Ketchum / SVWSD Water Reclamation Facility  
Aeration Upgrades

**ADDENDUM NO. 3**

February 21, 2024

**PROCESS  
BLOWER BUILDING  
AERATION BLOWER SECTIONS**

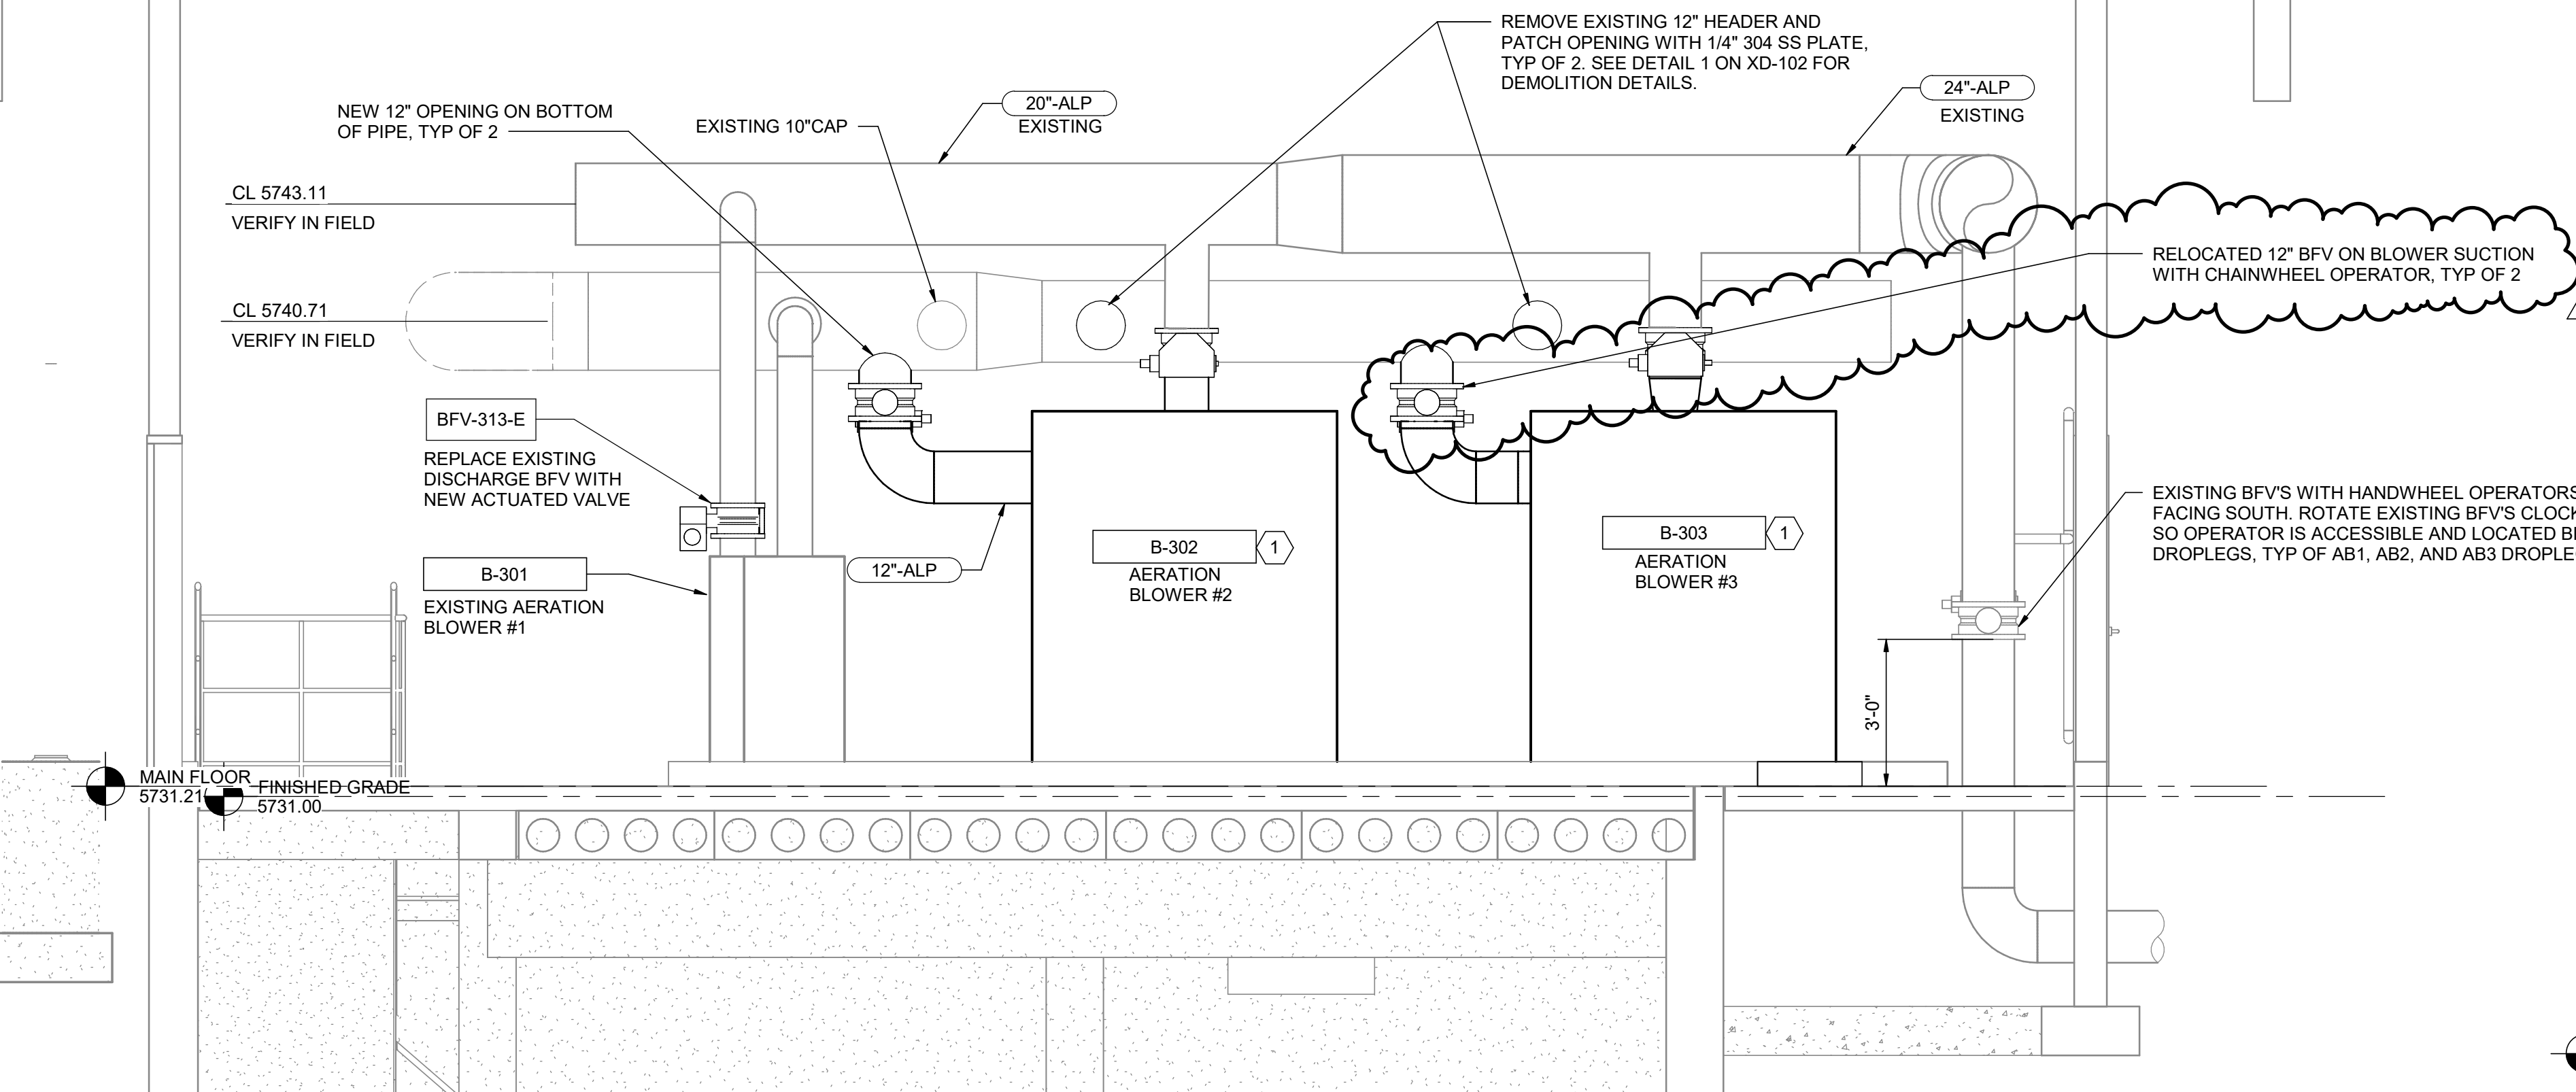
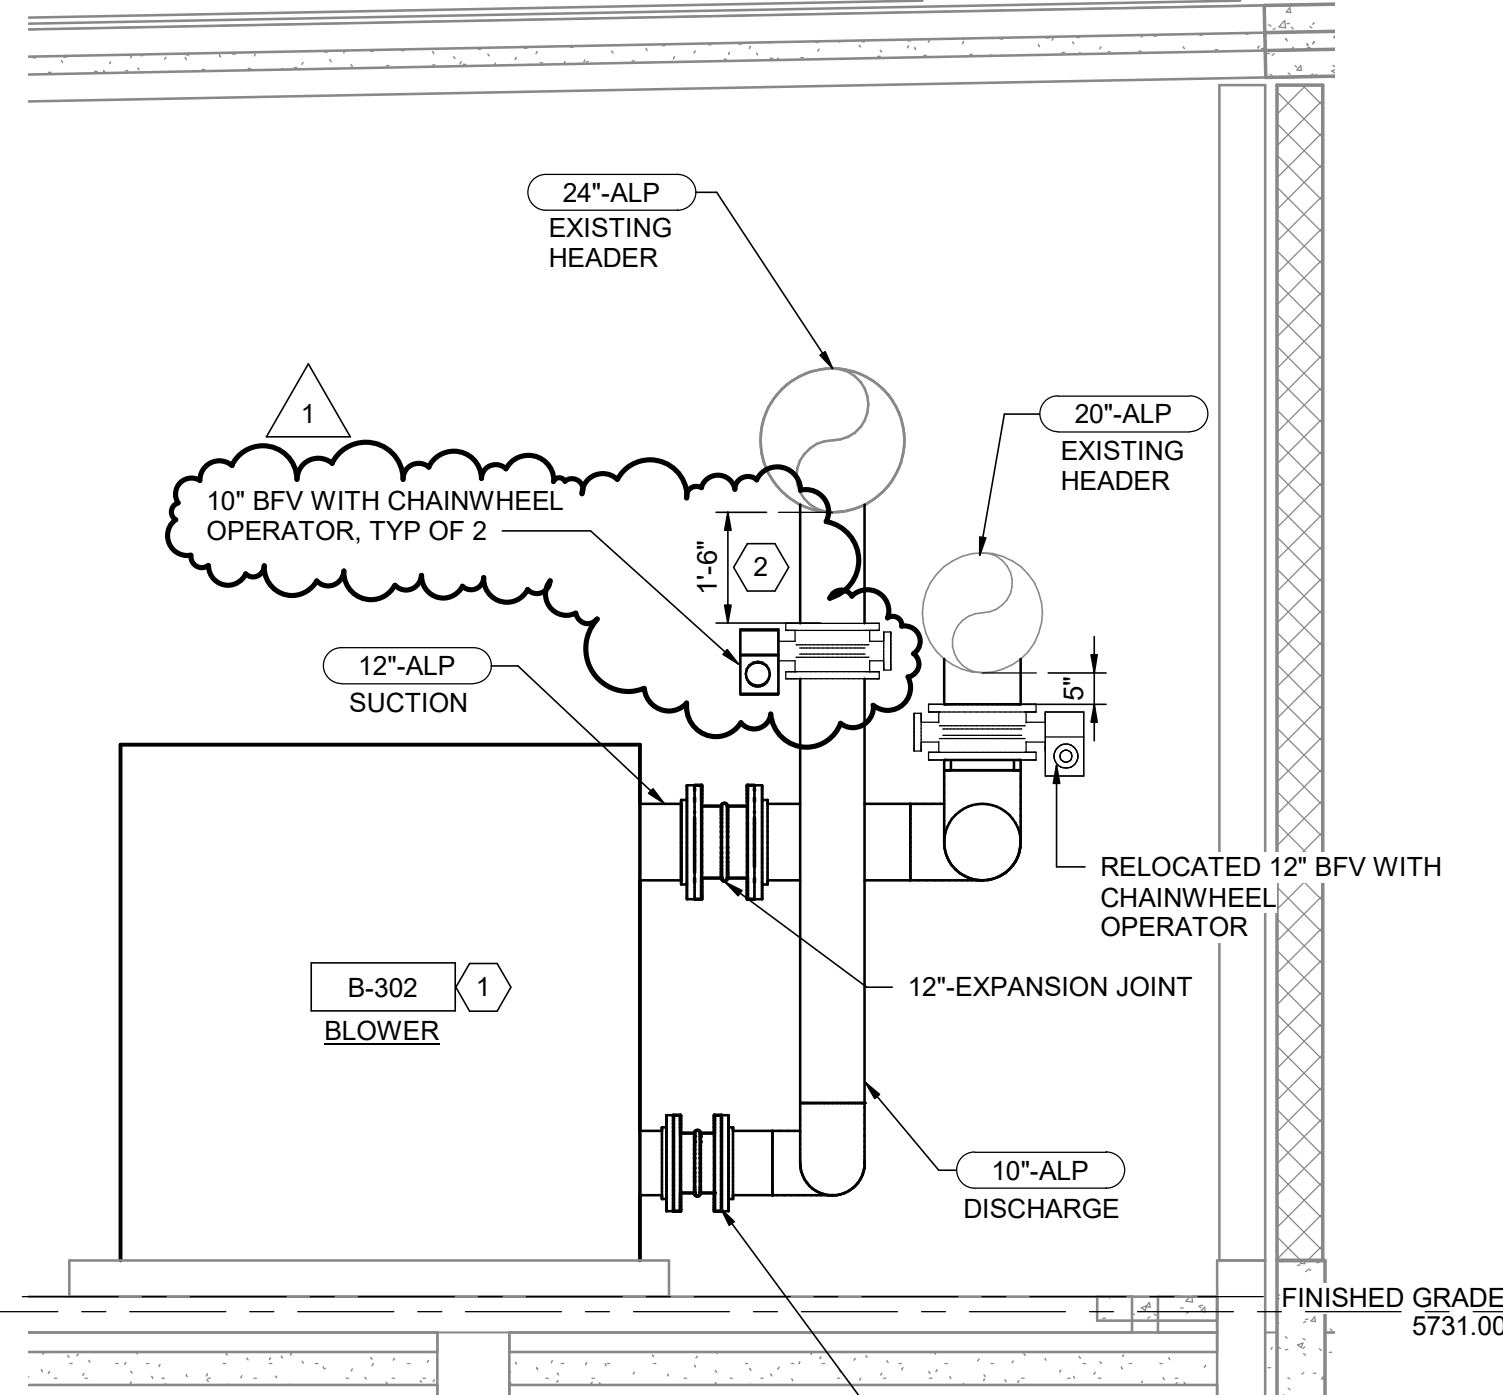
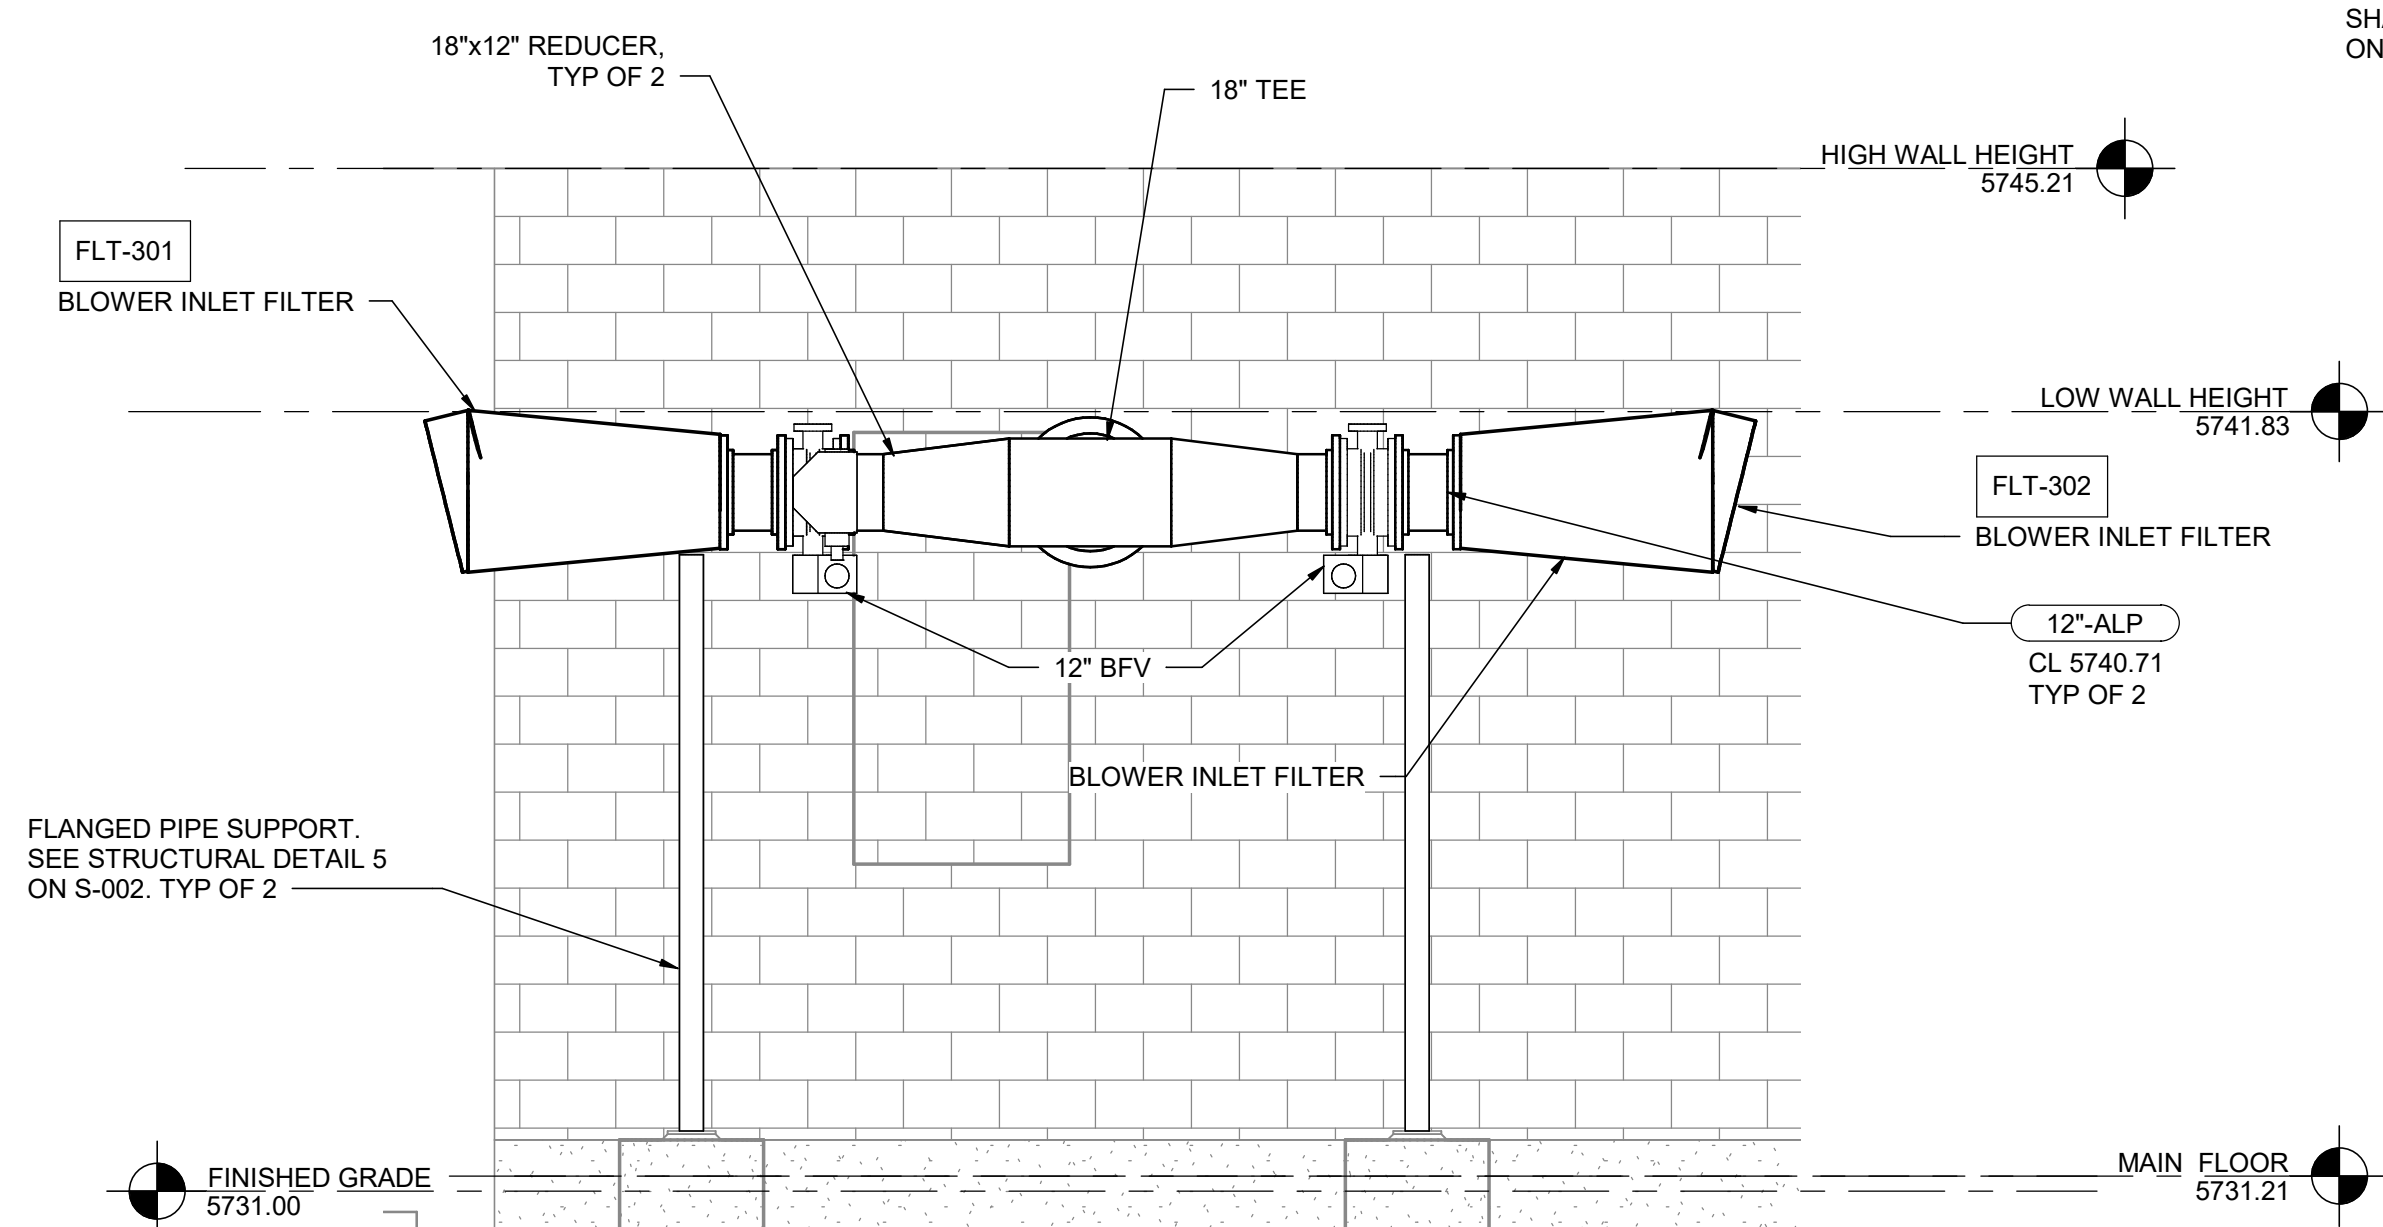
3.09 Drawing D-301: Process - Blower Building Aeration Blower Sections: Modify the Drawings as shown by Addendum No. 3 revision.
